Addendum 1

City of Canton, Ohio
Purchasing Department
218 Cleveland Ave. SW, 4th floor
Canton, Ohio 44702

Fairmount Area Watermain Replacement – Phase 1

TYPICAL WATER SERVICE
(C94)

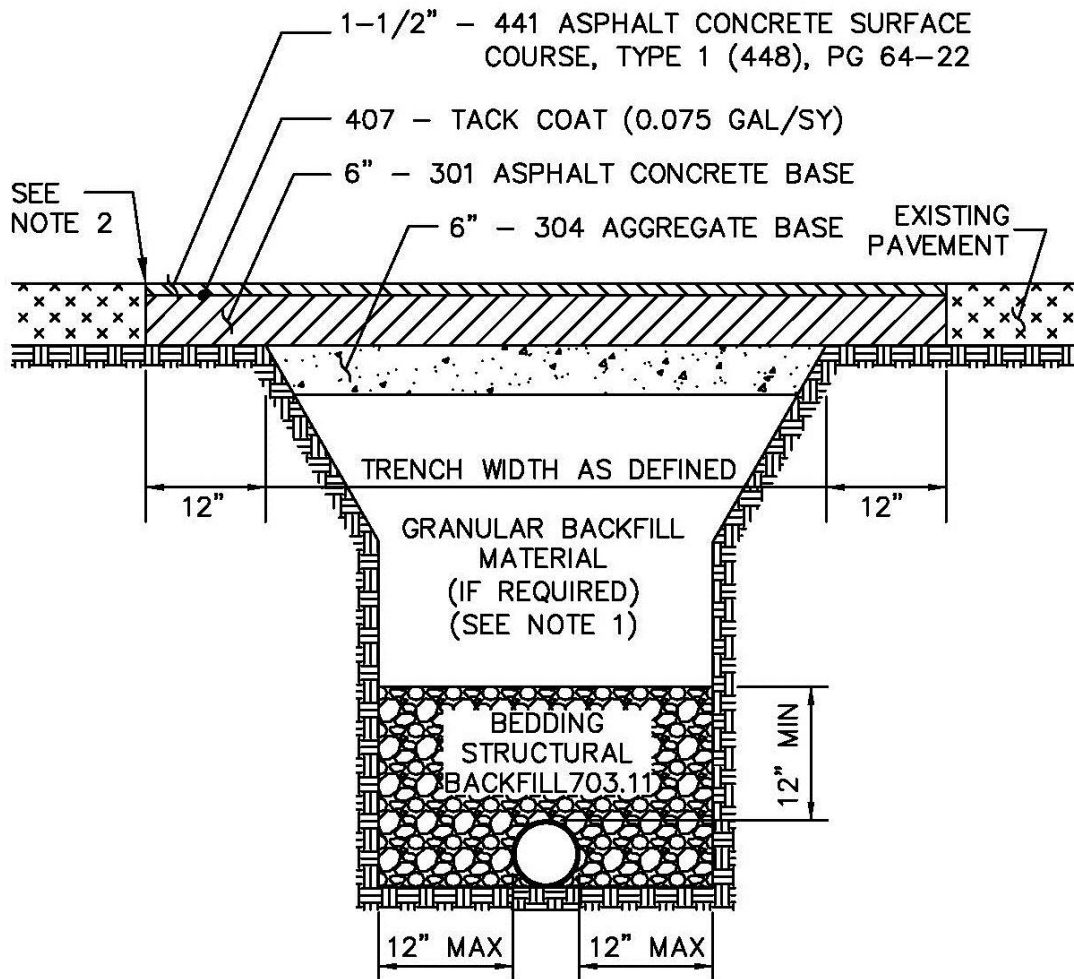
- E. In Appendix C: Specifications and Drawings, plan sheet 35:
- The “Typical Water Service” detail shall be replaced with the attached detail.
- F. In Appendix C: Specifications and Drawings, plan sheet 36:

- 1.) CORPORATION STOP AND ASSEMBLY SHALL BE AS FOLLOWS:
 1" CORP. STOP ON DIP: INSTALL AT THE 2:00 POSITION, A MUELLER H-15008 CORPORATION STOP WITH A COMPRESSION CONNECTION.
 1" CORP. STOP ON PVC C909: INSTALL AT THE 2:00 POSITION, A MUELLER H-15008 CORPORATION WITH A COMPRESSION CONNECTION AND A FORD, STAINLESS STEEL, EPOXY COATED TAPPING SADDLE (FC202 STYLE).
 1 1/2" CORP. STOP: INSTALL AT THE 2:00 POSITION, A MUELLER H-15008 CORPORATION STOP WITH A COMPRESSION CONNECTION AND A FORD, STAINLESS STEEL, EPOXY COATED TAPPING SADDLE (FC202 STYLE).
 2" CORP. STOP: INSTALL AT A 45° ANGLE, A MUELLER H-10003 CORPORATION STOP WITH 2" IRON TOP, A STANDARD NO LEAD BRASS 45° ELBOW AND A MUELLER H-15428 COMPRESSION MALE WITH INSERT COUPLING. ASSEMBLY SHALL ALSO CONSIST OF A FORD, STAINLESS STEEL, EPOXY COATED TAPPING SADDLE (FC202 STYLE).

- 2.) A SERVICE CLAMP MUST BE USED WHEN THE MAIN SIZE IS 2 INCH OR SMALLER.
- 3.) HEAVY DUTY VALVE BOXES, COMPLETE, MUST BE USED IN PLACE OF ROADWAY BOXES WHEN THE CURB VALVE IS LOCATED IN ROADWAYS OR ASPHALT DRIVES.

- 4.) WHEN CONNECTING A NEW 1" SERVICE TO AN EXISTING 3/4" SERVICE, THE CURB VALVE SIZE SHALL BE A 1"x3/4" REDUCING CURB VALVE.
- 5.) BRASS REDUCING BUSHINGS OR SWIVEL ELLS WILL NOT BE ALLOWED.

- 6.) APPROVED EQUALS MAY BE USED IN PLACE OF SPECIFIED ITEMS.
